T.I. no.: 2018 - 13 Updated: -	Topic: SCClub Software 1.5.4
--	-------------------------------------

Date: 02.07.2018	Priority	Need for action
Affected machines: SC Club	High	As soon as possible
From serial number: -	Medium	On next visit to the machine
As of date: -	X Low	X FYI only

IMPROVEMENTS

Machine cleaning with PIN entry

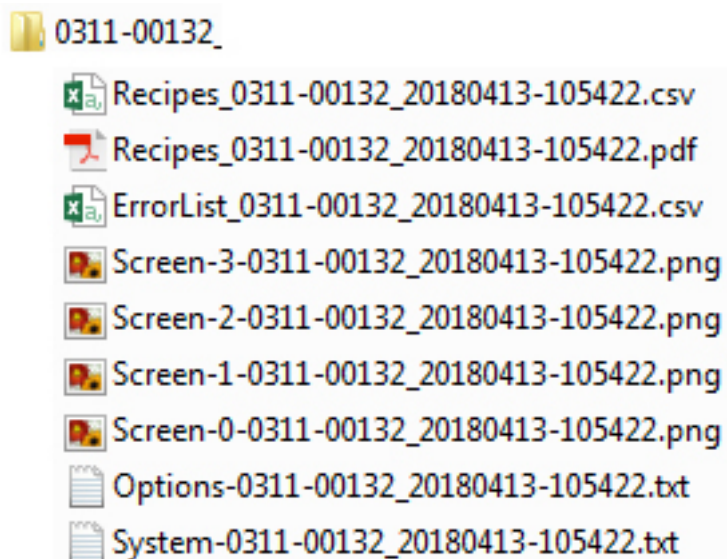
From the field it has been reported that although a PIN for the cleaning menu was programmed on a machine, the Click & Clean milk system cleaning can still be carried when requested without prior input of the cleaning PIN.

With new software, if a cleaning PIN has been programmed, this must also be entered for a pending Click & Clean milk system cleaning.
